MANATEE COUNTY

SUBJECT: Invitation for Bid #09-3281-OV
Suburban System Water Line Replacement Project, Phase 1
(Project No. 60747.70)

ADDENDUM #2

Addendum No. 2 – Addendum Items, Questions and Responses

JOB No. 386879.WM
 CAD FILE ADENDWG1
 SHEET NUMBER
 ADDENDUM DRAWING No. 1
 11-4-09

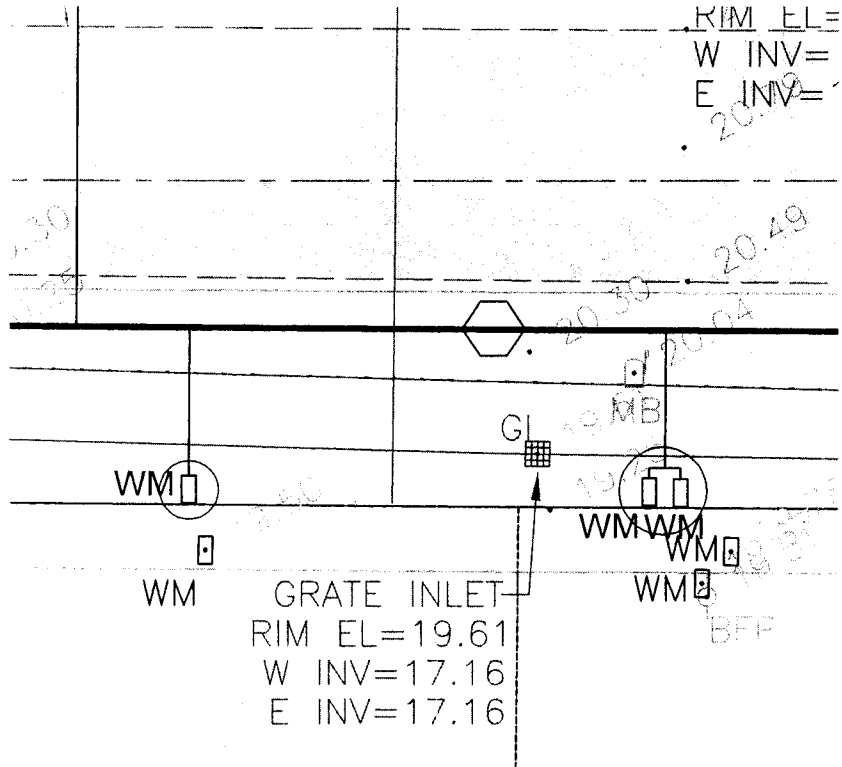
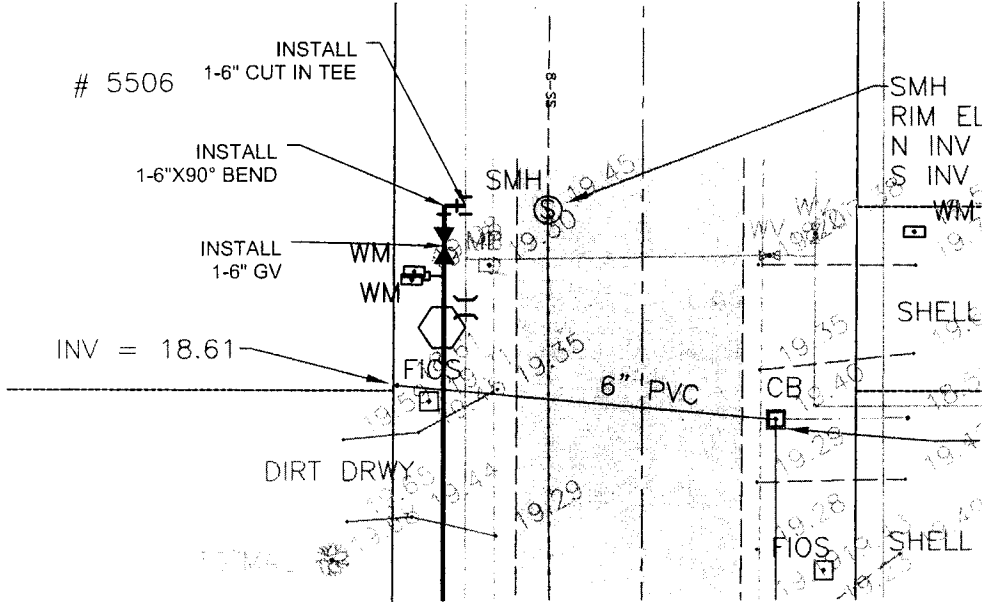
Addendum Drawing No. 1: Show some meter connection clarifications and a minor change to the drawing legend.

Item No. 2: Refer to the contract documents, contract drawings: For some Right-of-Entry meter locations, the drawings show the new service lines for the property in question connecting to the existing meter location. At these locations, new service lines are to be installed to connect with new Right-of-Entry meter locations shown on the drawings. An example of this drawing clarification is shown on Addendum Drawing No. 1. Addendum Drawing No. 1 also provides a clarification to the Legend shown on Sheet G-2. The symbol for existing water meter is revised.

REVISED RIGHT OF ENTRY TYPICAL
CONNECTION CALL OUT
 NTS

REVISED LEGEND SYMBOLS
WATER METERS & CONNECTIONS

JOB No. 386879.WM
 CAD FILE ADENDWC2
 SHEET NUMBER
 ADDENDUM DRAWING No. 2

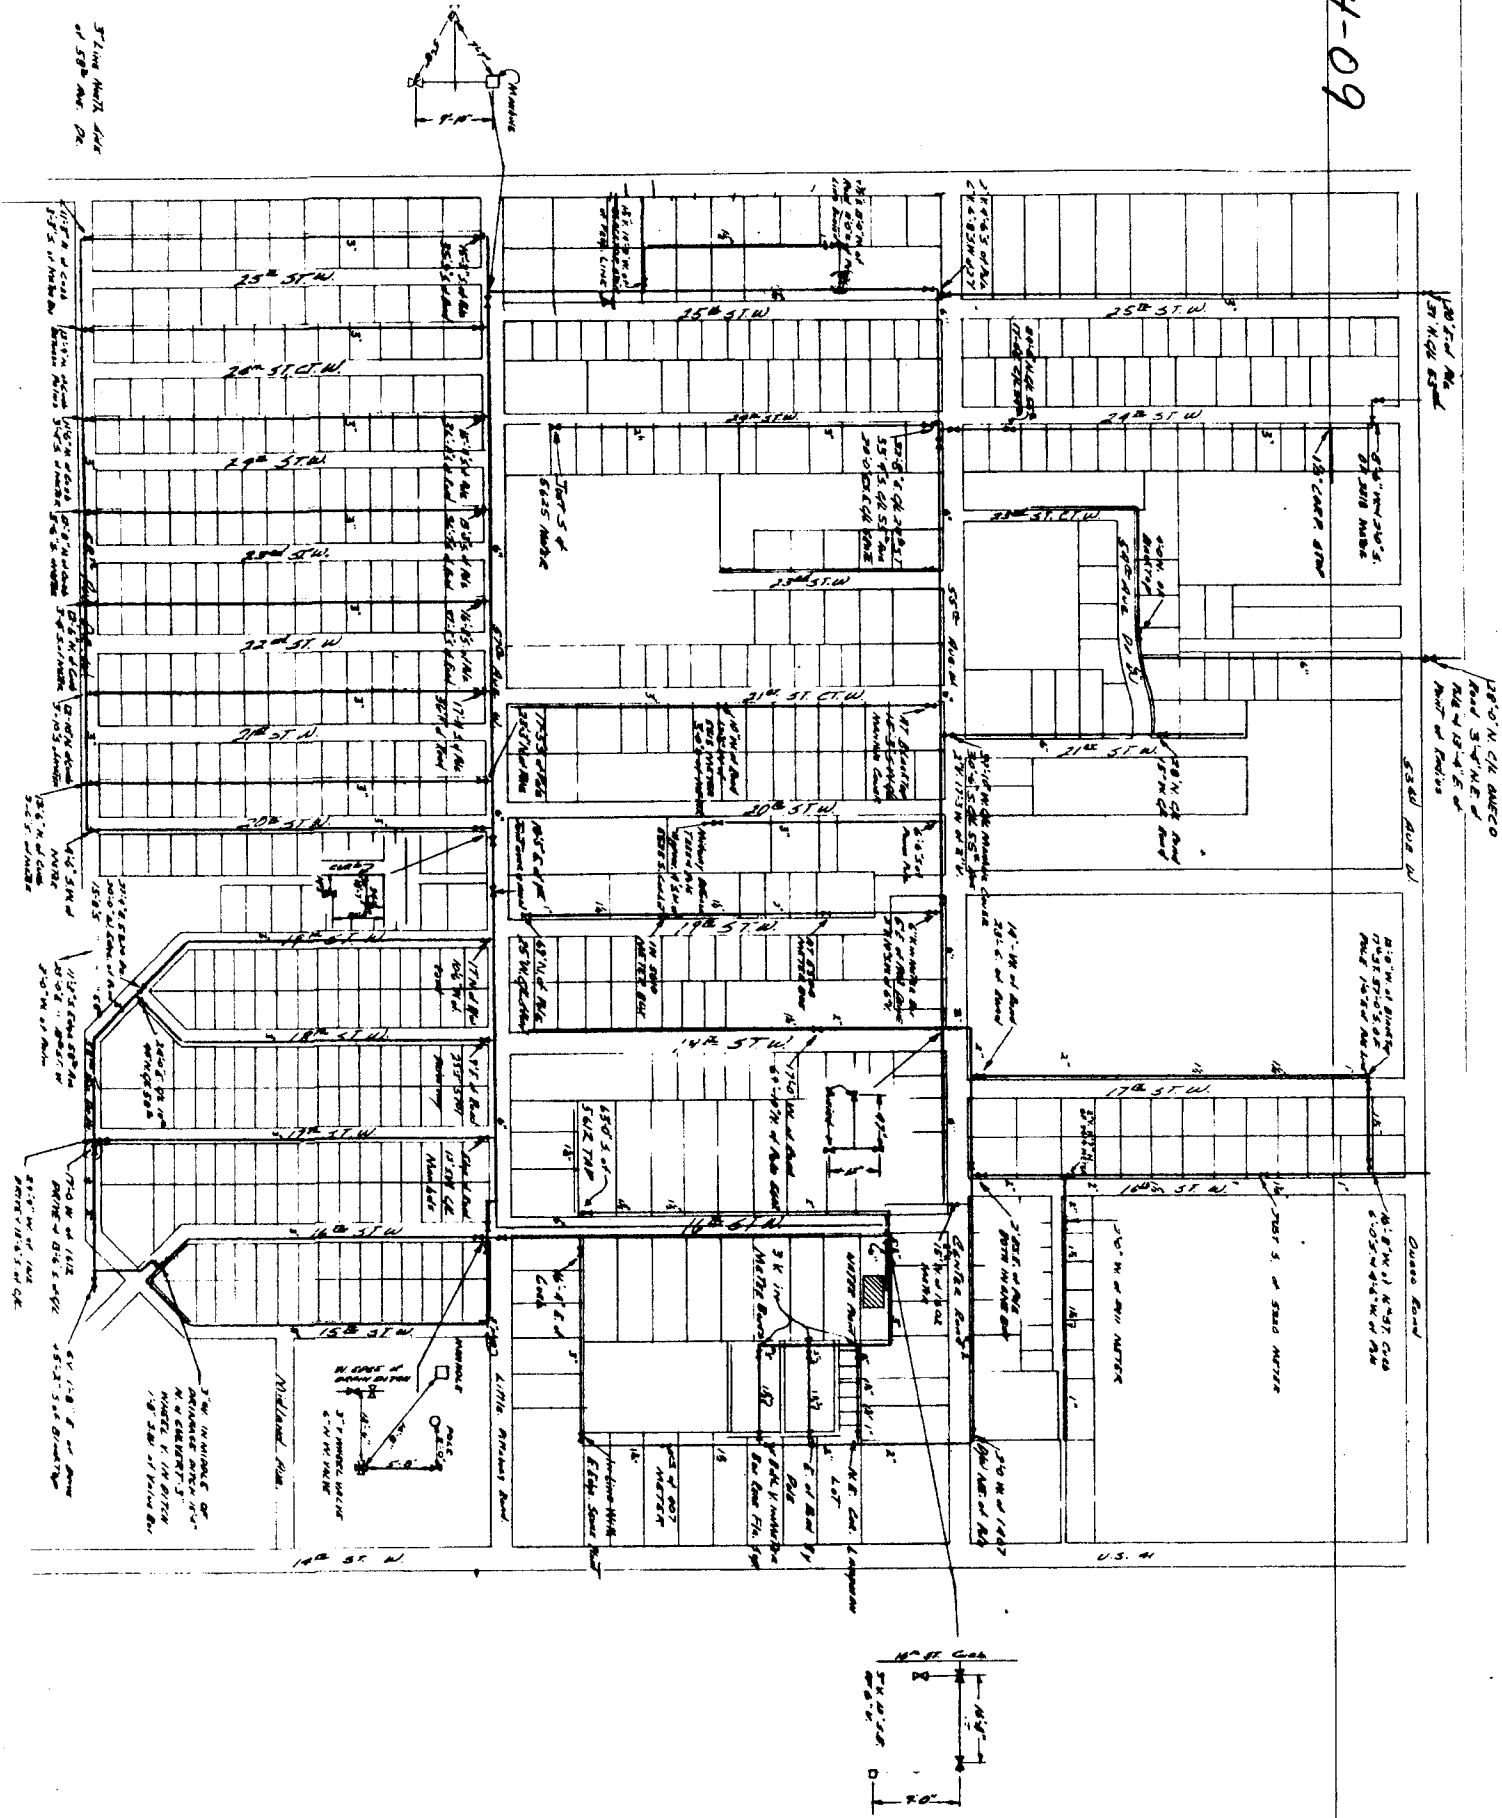
Addendum Drawing No. 2: Shows a revised distribution connection on 16th St. W.

Item No. 4: Refer to the contract documents, contract drawings: At the north end of 16th Street W, revise the connection to the existing water line as shown on Attachment Addendum Drawing No. 2.

REVISED MEDIUM DIAMETER DISTRIBUTION
 CONNECTION IN THE VICINITY OF 5606
 16th STREET WEST - SHEET C17

Response: Revise this connection. Install a cut-in tee and valve at this location rather than a tapping sleeve and valve. The County does not permit size on size taps.
